MEMORANDUM

SUBJECT: Mandatory Referral Petition 05105-MCPS-1
New Hampshire Estates Elementary School campus renovation
8720 Carroll Avenue
Silver Spring Policy Area

This memorandum is Transportation Planning staff's adequate public facilities (APF) review of the subject mandatory referral petition to permit the renovation of the New Hampshire Estates Elementary School parking lot.

Exhibit 1: Current conditions

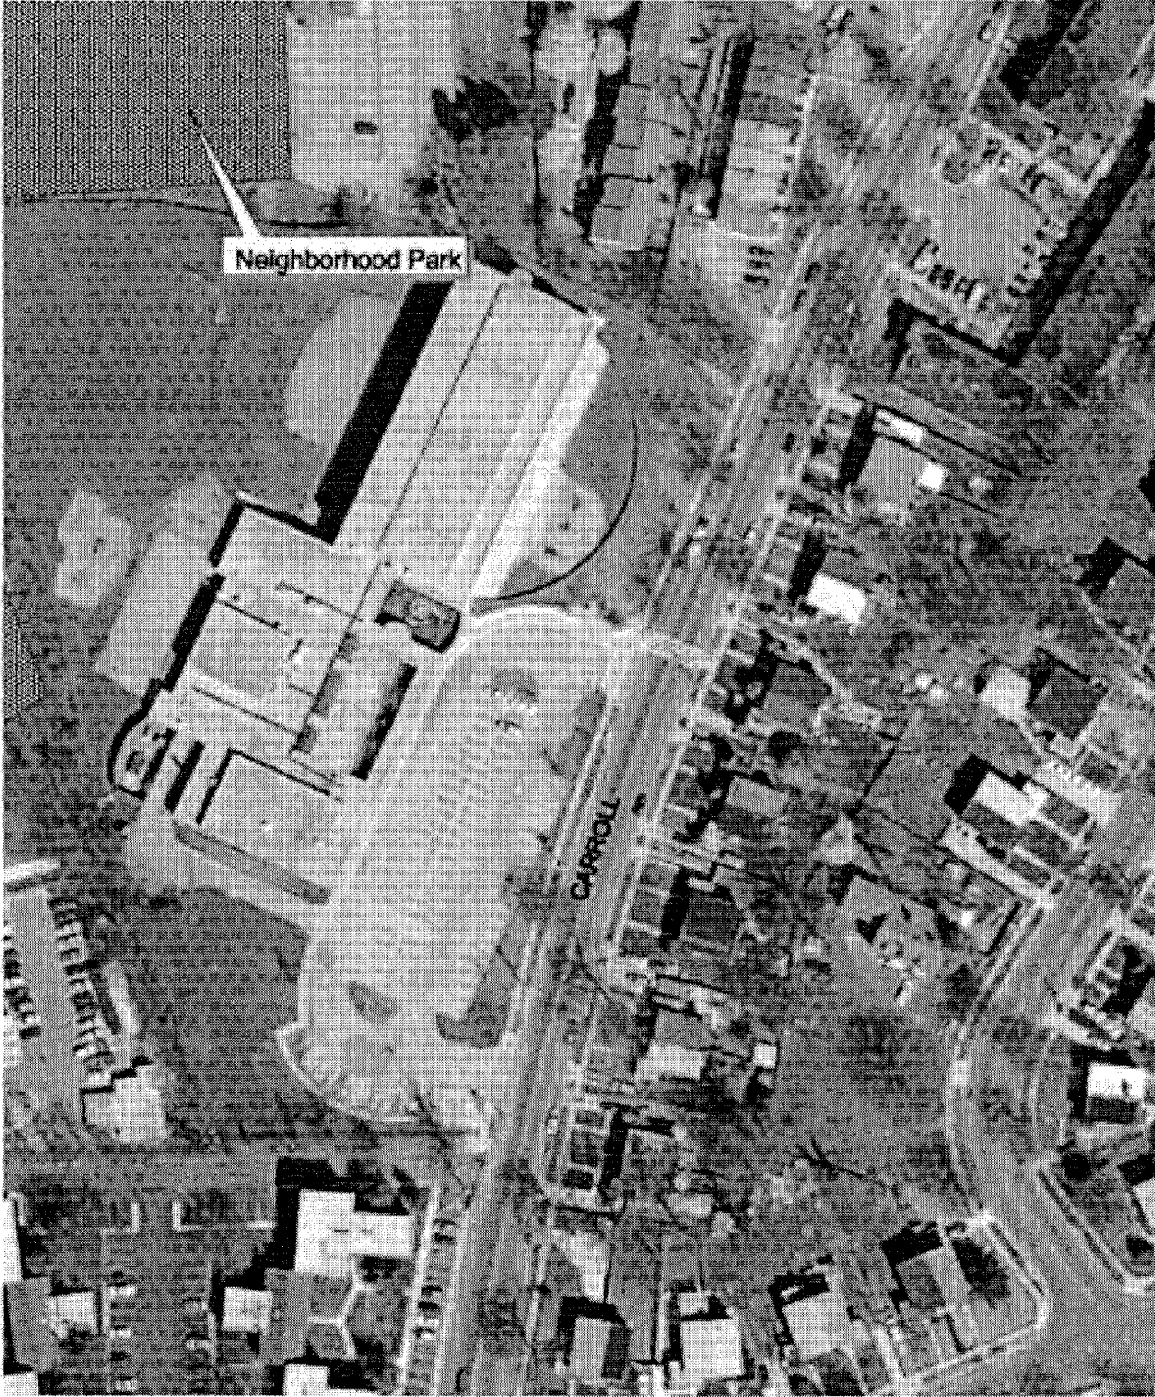
Presently, the school is accessed from Carroll Avenue by means of a circular loop driveway. The driveway offers one-way access to the front of the school for both buses and private vehicles as shown in Exhibit 1. Staff parking is incorporated into the design of the front lot, with additional parking located to the southern side of the campus. Current staff parking demand exceeds the on-site capacity and visitors and part-time staff often park along Carroll Avenue.

Exhibit 3: MCPS proposal with staff comments

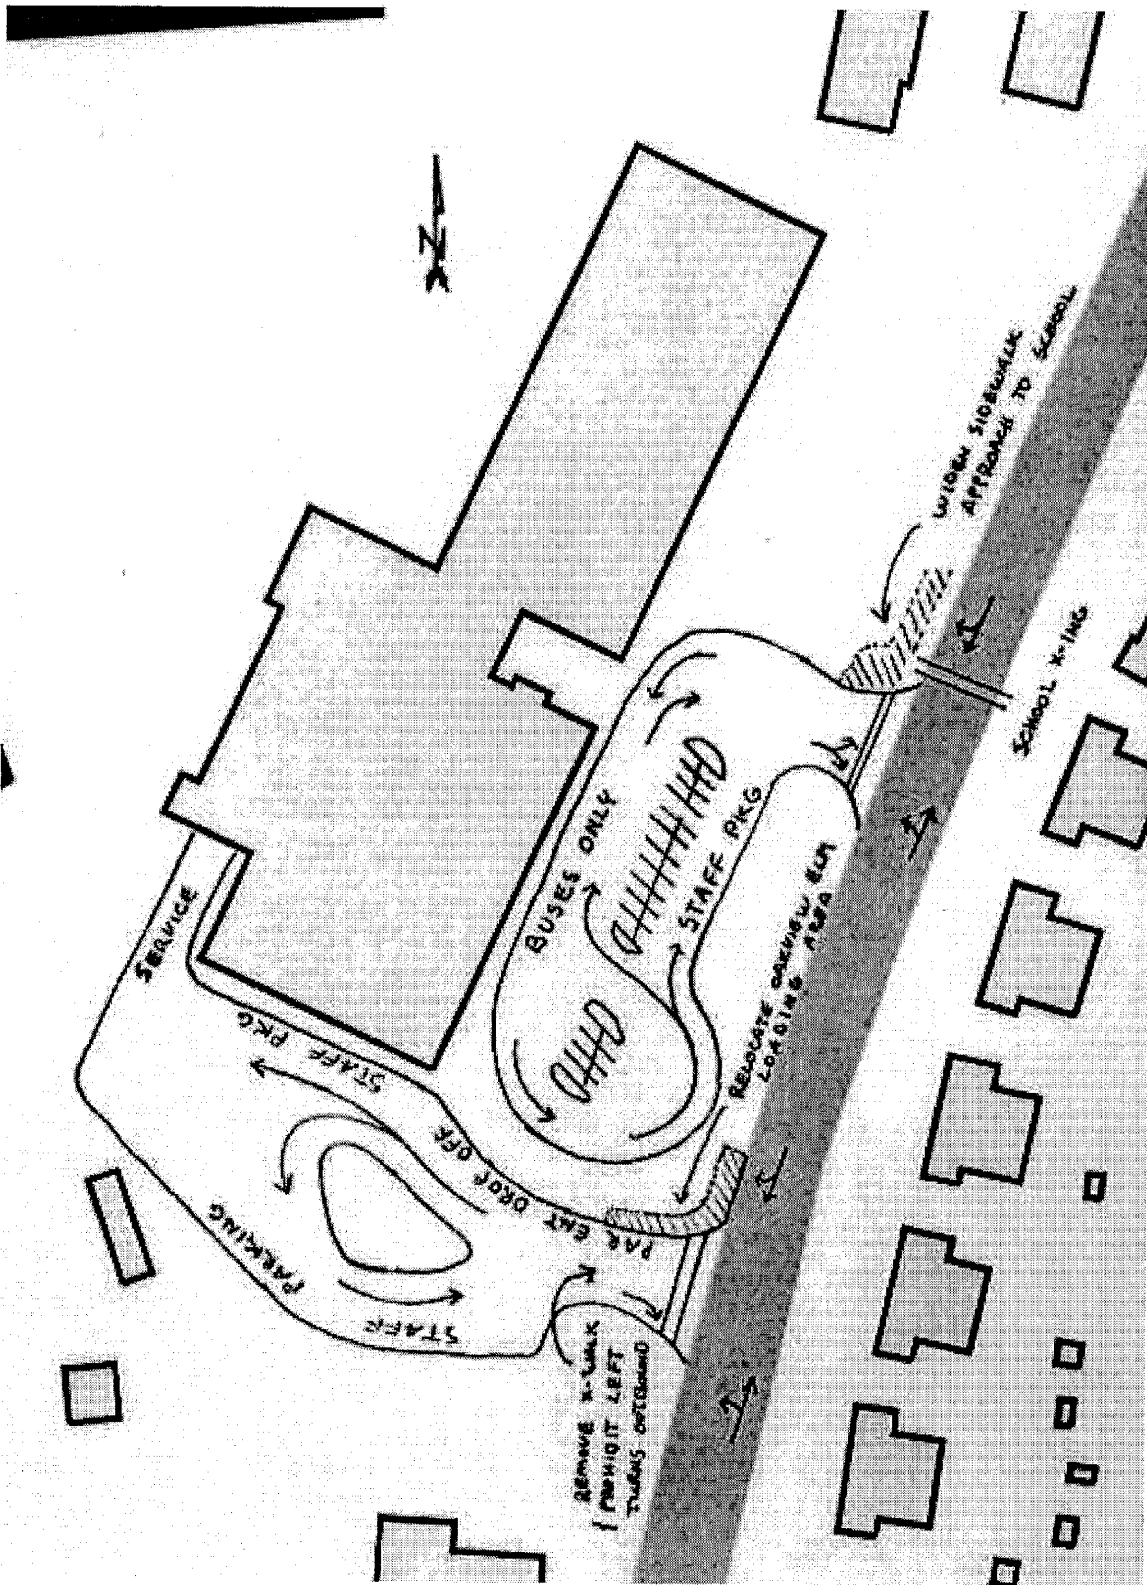
1. Prohibit outbound left turns during peak arrival and departure times (8-9 AM) from the parent/staff access driveway.
2. Widen the sidewalk along Carroll Avenue at the school's northern driveway to facilitate student pick-up activities.
3. Relocate the proposed auxiliary boarding area for Oakview Elementary students from within the parent/staff parking lot to the front of the school along Carroll Avenue north of the parent/staff access driveway.

4. Extend the sidewalk abutting the parent drop off area to connect with the sidewalk along Carroll Avenue.
5. Eliminate the proposed pedestrian crosswalk across the parent/staff access driveway.
6. Develop and distribute informational packets for parents and teachers in advance of proposed changes in on-site traffic access and circulation.
7. Coordinate with DPWT regarding the following operational issues:
 - a. Review the operations of the new circulation patterns during autumn 2006 and provide additional traffic control personnel if needed.
 - b. Repair and maintain school zone flashers located along Carroll Avenue.
 - c. Review on-street parking prohibitions and determine with DPWT whether current restrictions are adequately enforced and appropriate for school related activities.

Transportation Planning staff considers the proposed changes a complication to the traffic operations along Carroll Avenue, and especially to the duties of the crossing guard with respect to controlling vehicular traffic. The proposed design with two, full-movement, driveways results in more conflict points (although the number of turning vehicles onto and from Carroll Avenue will not increase). By creating two distinct full service driveways (ingress and egress) within close proximity of each other (240 feet), the potential for the operation of one driveway to affect the other is greater than the current configuration of one entrance driveway and one exit driveway were maintained. This concern is augmented by the lack of supplemental traffic controls proposed for the parent and staff access driveway. **Staff recommends prohibiting left turns from the parent/staff access driveway during morning drop-off periods to reduce the potential for conflict.**

Staff observed considerable pedestrian activity concentrated at the northernmost corner of the entrance driveway (near the crossing guard station), so additional sidewalk width and maneuvering space would be beneficial. **Staff recommends widening the sidewalk/staging area at this location** to improve pedestrian access, including widening up to 50 feet of the sidewalk along the west side of Carroll Avenue north of the school's northern driveway.

The site is also designed to accommodate a transfer bus loading point for older students who travel on a daily basis to Oakview Elementary School. The design submitted by MCPS included a loading area in the southeast corner of the campus with an angled crosswalk connection across the parent/staff access driveway throat. The design was intended to potentially accommodate bus loading from the parent/staff driveway itself. MCPS has subsequently confirmed that the Oakview Elementary School transfer bus will use the Carroll Avenue curbside for loading and unloading. Staff recommends three design changes related to the Oakview Elementary School bus loading/unloading area:

- Relocate the loading/unloading area to the north side of the parent/staff driveway.
- Remove the angled driveway crosswalk; it would not be needed after relocation of the Oakview bus loading area, and the presence of two crosswalks less than 100 feet apart will be confusing, particularly within the parent drop off area.
- Extend the sidewalk abutting the parent drop off area to connect with the sidewalk along Carroll Avenue.
